May 12, 2022 – 7:00 pm Village Hall 235 Hickory Street, Pewaukee, WI 53072

# Village of Pewaukee Plan Commission Engineer's Report for May 12, 2022

# Village of Pewaukee Plan Commission Engineer's Report for May 12, 2022

# Exhibit B - Lot 10 with Hawthorne

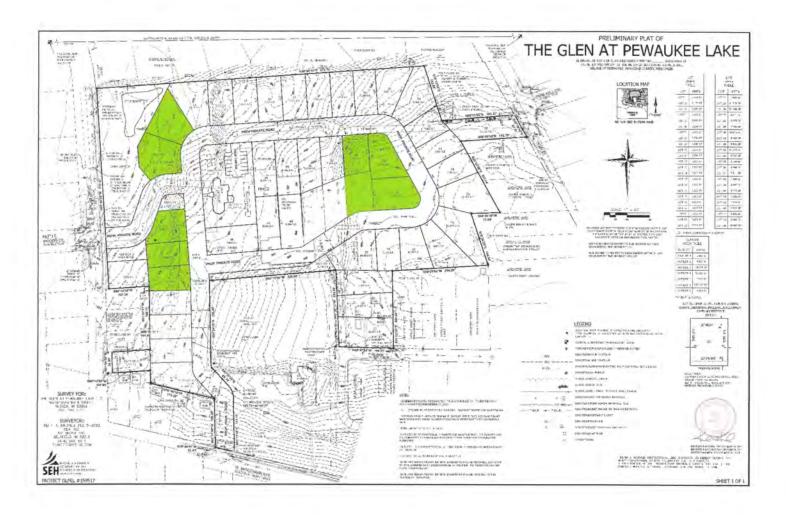
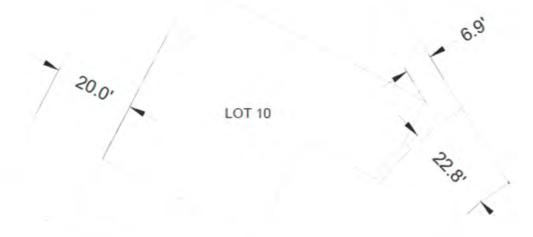
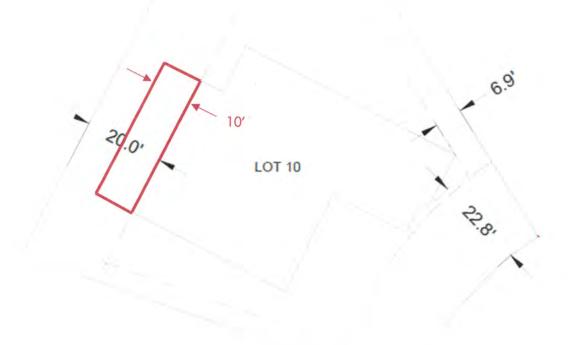
Working through our home and lot offerings at The Glen at Pewaukee Lake we are discovering some challenges related to the rear setbacks and elevated decks. We request an exemption to the rear yard setback for decks on Lots 6-10, 38-41. On this select set of lots the total depths are rather shallow and thus the issue. The space behind these lots abut another lot we control or an outlot. At minimum we'd like to extend an additional 10-feet into the rear setback with a deck. The deck will not be enclosed but may have architectural details such as a pergola. All but one of these lots offer a full or partial basement exposure, so a typical patio which is allowed off the main floor isn't possible.

Enclosed is an example to highlight the challenge; on Lot 10 we laid out the Hawthorne which is an 1,888 square foot home with courtyard entry two car garage. The home fits within the setback requirements; however, we are unable to add a deck to rear of this home based on current setback requirements. As we talk with potential buyers, they are asking for these outdoor spaces.

Currently, no space for a deck off the rear of the home.

Requesting space for a deck off the rear of the home.
